From: Oliver McGowan [REDACTED]
Sent: 30 September 2019 18:17
To: Jonathan Perks [REDACTED]
Cc: 'Peter Garrett' [REDACTED] Zac Denton <Zac.Denton@arun.gov.uk>
Subject: Re: Project Ref: FG/46/19/PL - Beach Car Park - Pre commencement condition

Arun District Council Project Ref: FG/46/19/PL

Project
Ferring Beach,
Car Parking & Ground Works

Drawing
Proposed Site Plan
& Photos for Info

01 PROPOSED SITE PLAN
Scale: 1:200

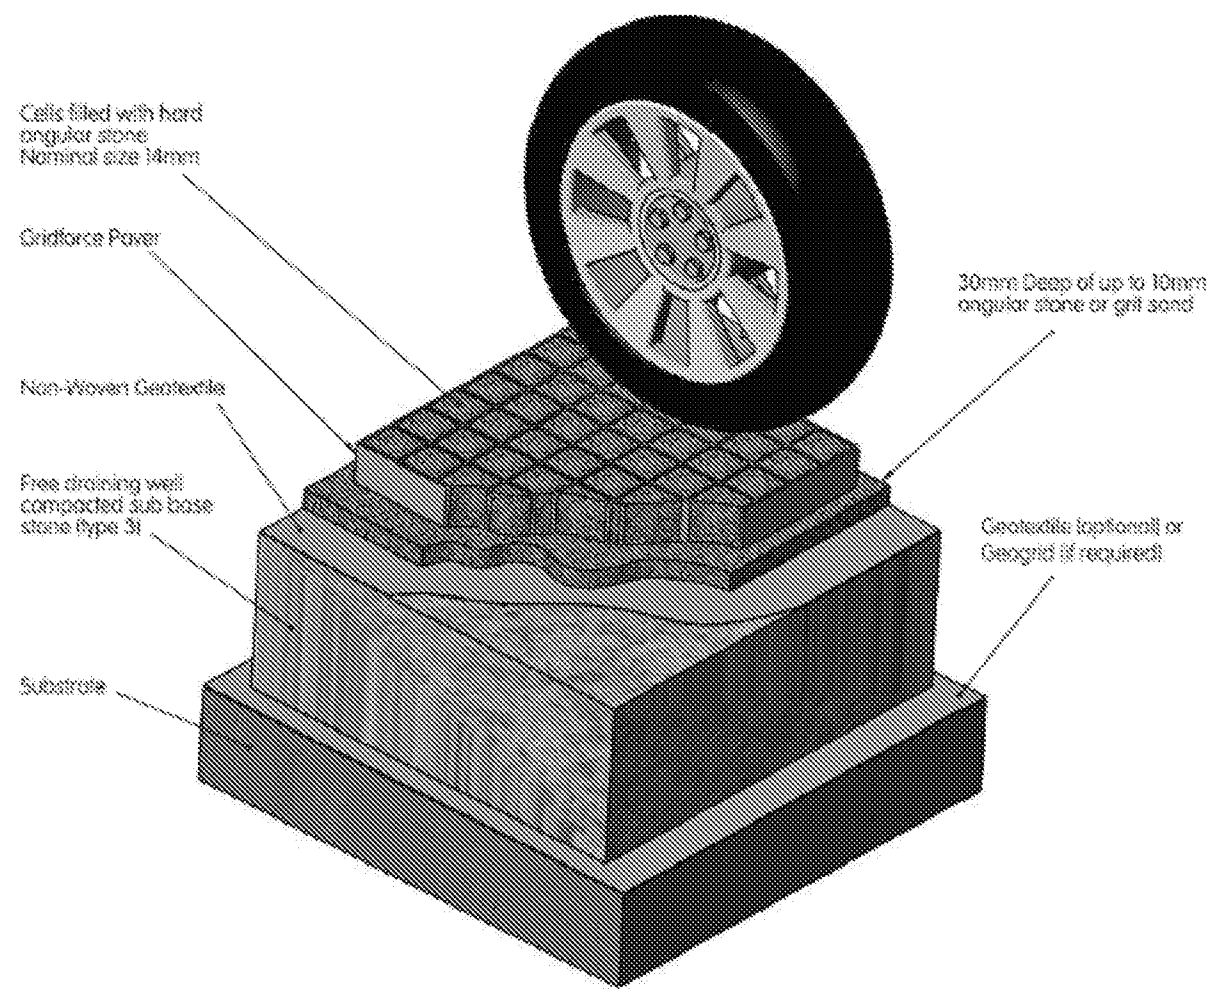
I've now been able to review your revised plans. Thanks for acknowledging the footpath's existence and providing 2m between bays 28 and 29; this is the minimum width acceptable (2.5m would be better if this can be configured) but I am wondering how vehicles will be prevented from parking on this land – will some low level fencing or other (bollards?) be installed on both sides?

As to the surfacing, I am grateful for the additional information. I've been looking around myself and noting these products, and I am satisfied to not object to this being laid as proposed subject to, as stated in your email 28 August 2019, the café maintaining the gravel infill – the café owner/ operator should make an inspection at least monthly, record this and take remedial action as appropriate.

Subject to clarifying the point above on fencing, please confirm a start date for works and whether the footpath can be kept open during that time; if that is not possible, it will be necessary to apply for a formal temporary closure of the path, which can be made through this link: <https://www.westsussex.gov.uk/land-waste-and-housing/public-paths-and-the-countryside/public-rights-of-way/request-a-change-to-a-public-path/temporary-path-closures/>

Thank you for your email. We will retain the minimum clear distance of 2m and will also include a plastic bollard with a sign to inform visitors to keep the marked area clear. We can also include further signage on the verge.

The contractor will ensure there is a clear PROW during the resurfacing works at all times. The contractor is carrying out the works in two phases to ensure vehicular and pedestrian access is maintained at all times. We have been in discussions with Environment Agency as they also had similar concerns maintaining clear access to the weed gate on the Rife. We have confirmed 24hr access will be maintained at all times.
